INTERIM STORAGE PARTNERS

Subject: Submission of ISP Draft Responses for RAIs and Associated Document
Markups from Part 2 CHB Cat B Design DRAFT Docket 72-1050
CAC/EPID 001028/L-2017-NEW-0002

1. Draft RAI Responses with associated application change pages (Public)

Add the SAR Chapter 7, "Installation Design and Structural Evaluation"**RAI NP-7-1:**

Figure 1-7
Cask Handling Building Plan

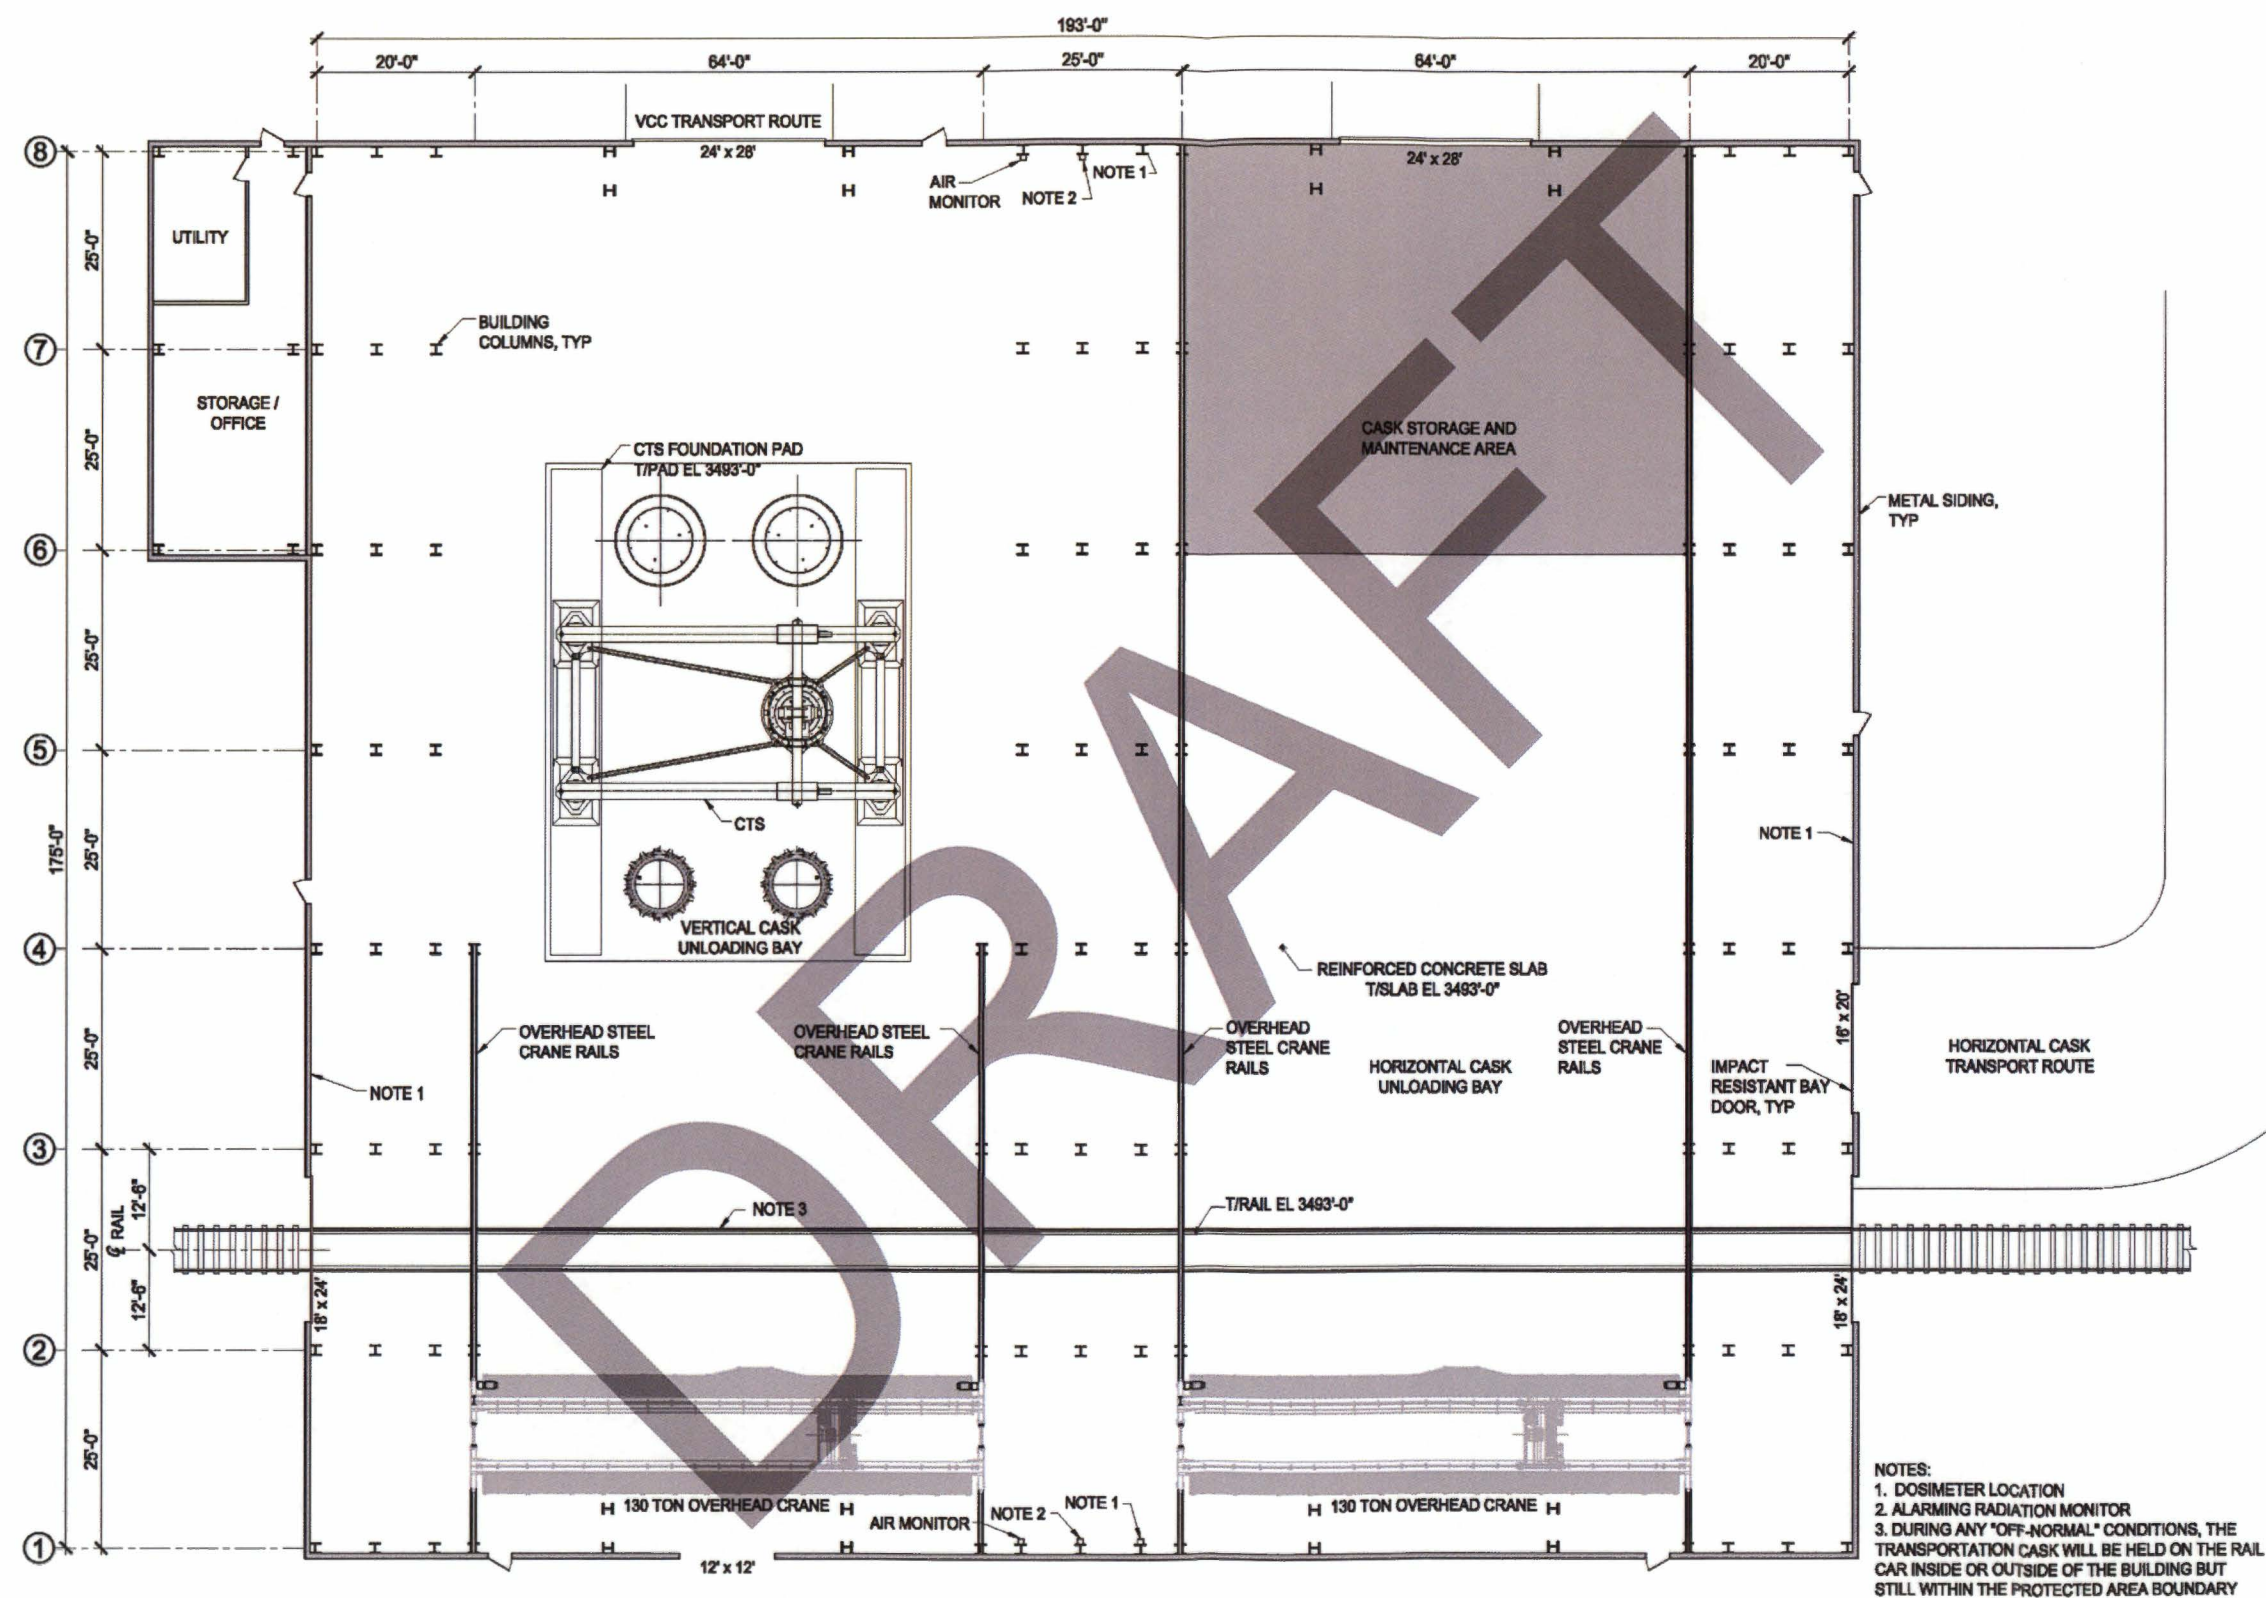
Provide a report for the design of the CHB that, at a minimum, includes the following: (1) the dimensions of all sections that have a structural role including locations, sizes, configuration, and spacing, (2) structural materials with defining standards or specifications, (3) location and specifications for assembly, and (4) fabrication codes and standards.

1. The dimensions (sizes, configuration, and spacing) of all sections with a structural role are provided in new Table 7-41 and new Figures 7-54 through 7-63 in the WCS CISF Safety Analysis Report (SAR), with a corresponding discussion added in Section 7.5.3.1.1.
1. Structural materials with defining standards and specifications are provided in new SAR Table 15-1.
2. Locations and specifications for assembly and connections are provided in new SAR Section 7.5.3.4.2.
3. Fabrication codes and standards are provided in New SAR Section 15.2.4.

←
RAI
NP-7-12

Figure 7-62
Cask Handling Building 3D STAAD.Pro Finite Element Model

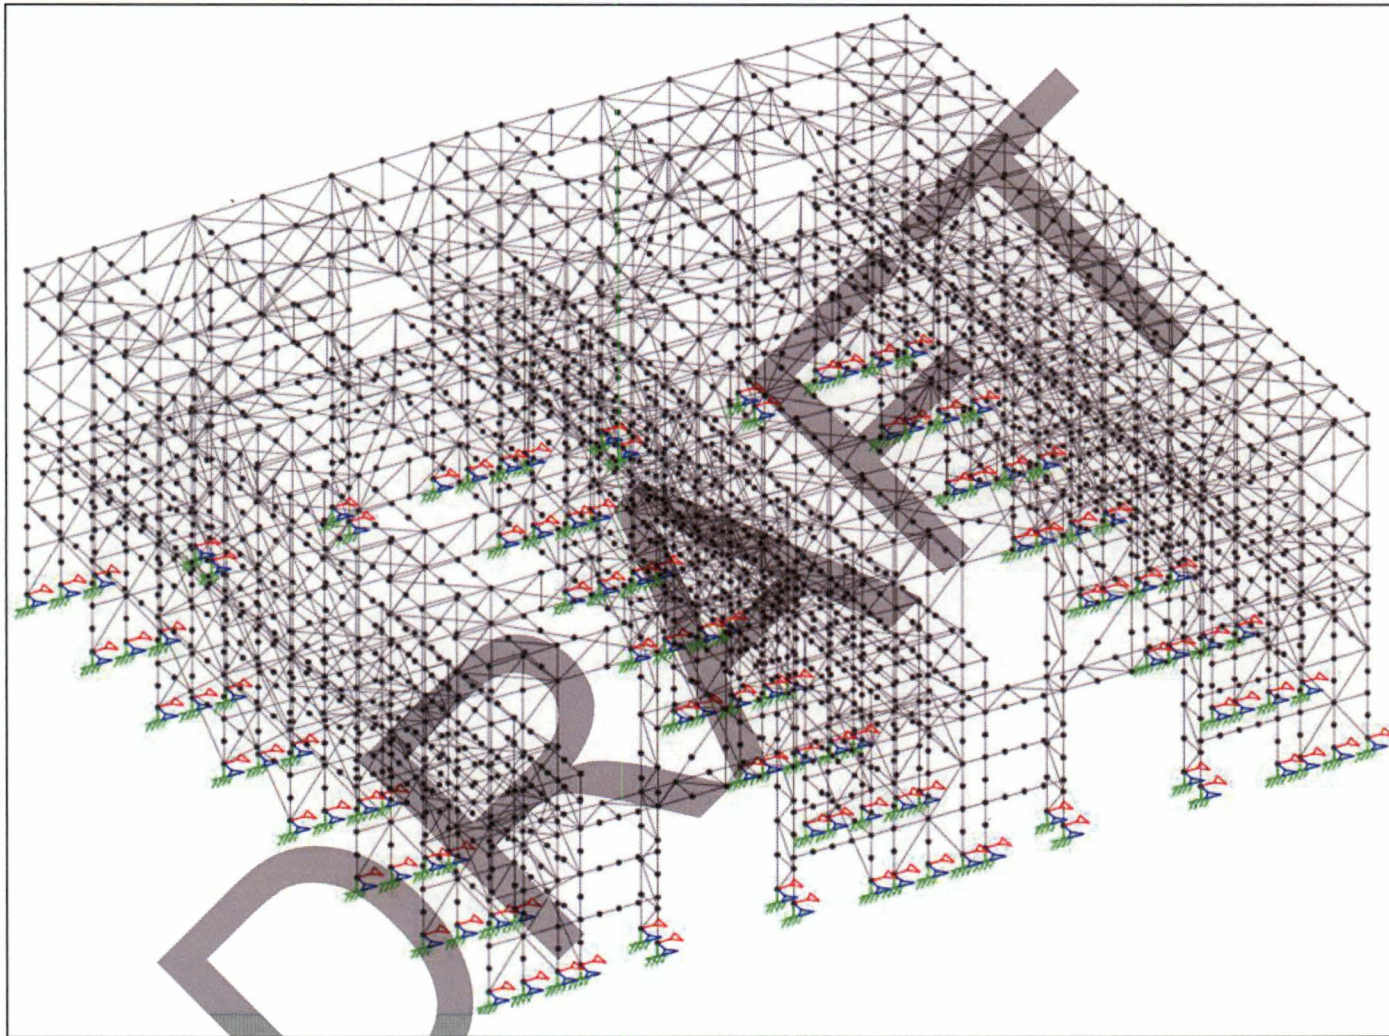
The report provided should include descriptions of the design method used, computer models used, and information on the application of the structural analysis methods used to determine the capacity of the CHB for service and natural phenomena loads. In addition, clarify if the modal response spectrum analysis will be the dynamic method used for the evaluation of seismic loads of the CHB.

Figure 7-62 shows an isometric view of the three-dimensional finite element analysis model generated in program STAAD.Pro (STAAD). The STAAD version utilized is the CONNECT Edition, Version 22.01.00.38, which is verified and validated under an ASME NQA-1 compliant quality program.
